Response to DSD comments dated 5 July 2024

Reply to DSD's comments on submitted Drainage Proposal Report
Lot 970 RP in DD 107 (A_YL-KTN_985)

B	DSD's COMMENT	RC	AY	RY	AUG 24
A	DSD's COMMENT	RC	AY	RY	JULY 24
	PLANNING DEPARTMENT SUBMISSION	RC	AY	RY	JUNE 24
REV	DESCRIPTION	CHECKED	APPROVED	DWN	DATE
PROJECT TITLE:					
STORMWATER DRAINAGE PROPOSAL					
Lot 970 RP IN D.D. 107					
DRAWING TITLE:					
DRAINAGE PROPOSAL PLAN AND TYPICAL DETAILS					
SCALE : N.T.S.		CAD FILE: CAD_REF			
DRAWN	RY	DRAWING NO. SDP001B			
S.D	RY				
DESIGNED	RC				
CHECKED	AY				
		B.D. REF. NO.:

Photo 3 showing the interior of existing catchpit

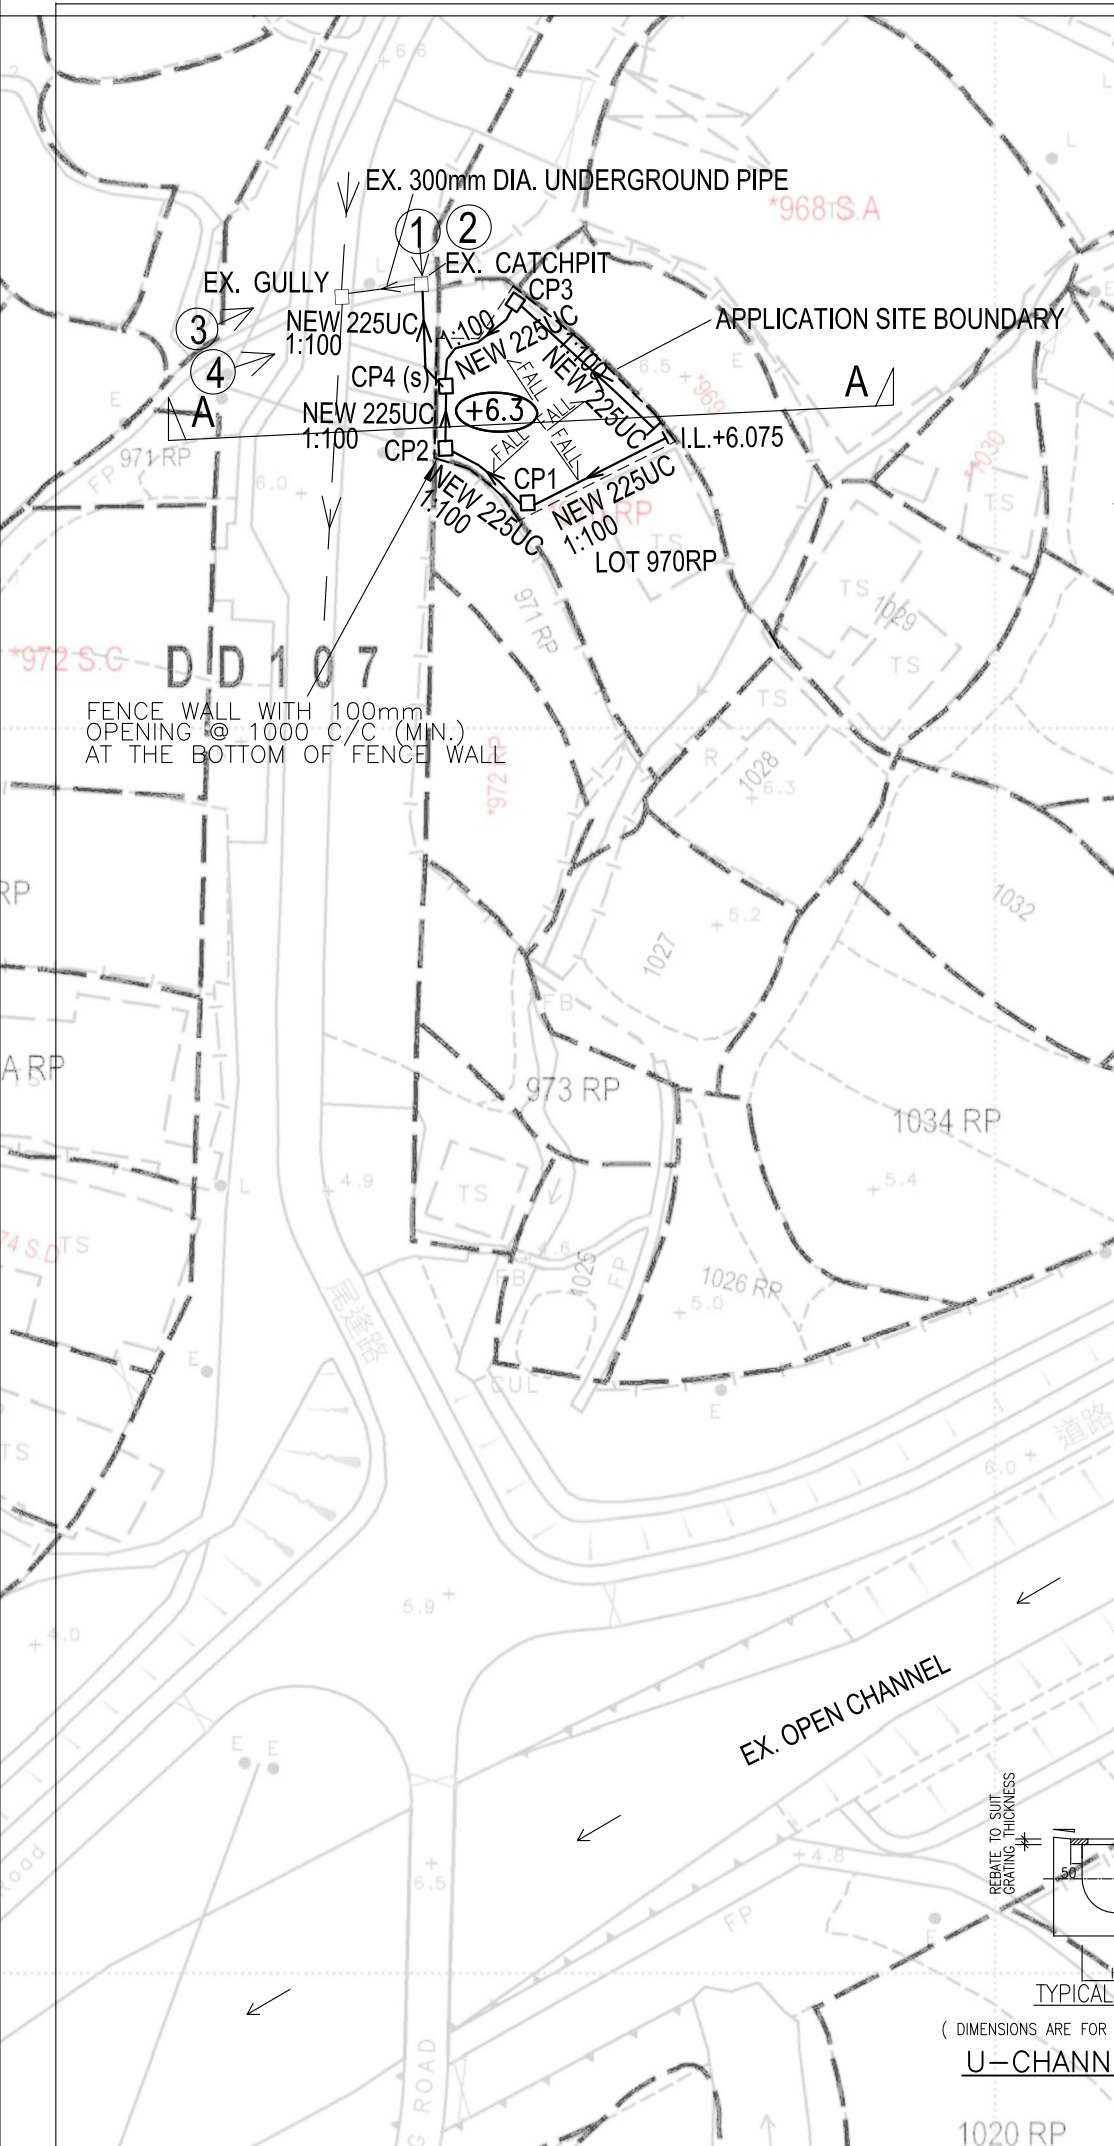
- g. The full alignment of the discharge path from the application site all the way down to the ultimate discharge point (i.e. existing gully) have been indicated on the revised drainage plan. Photos showing the interior of existing catchpit together with existing underground pipe are attached for your reference.

CONNECTION DETAILS OF EXISTING CATCHPIT AND PROPOSED 225UC

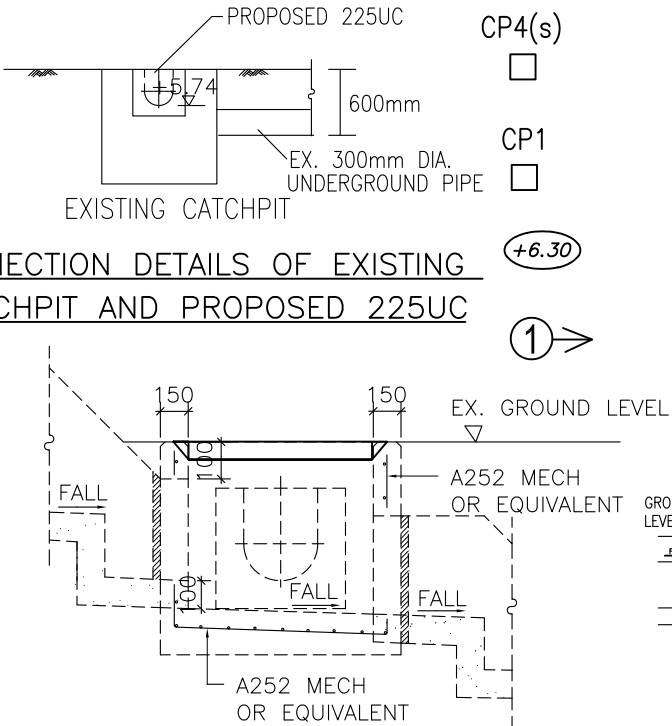
- e. Flow direction is indicated on the drainage plan.
- f. Details of existing catchpit and connection details have been shown on the revised drainage plan.
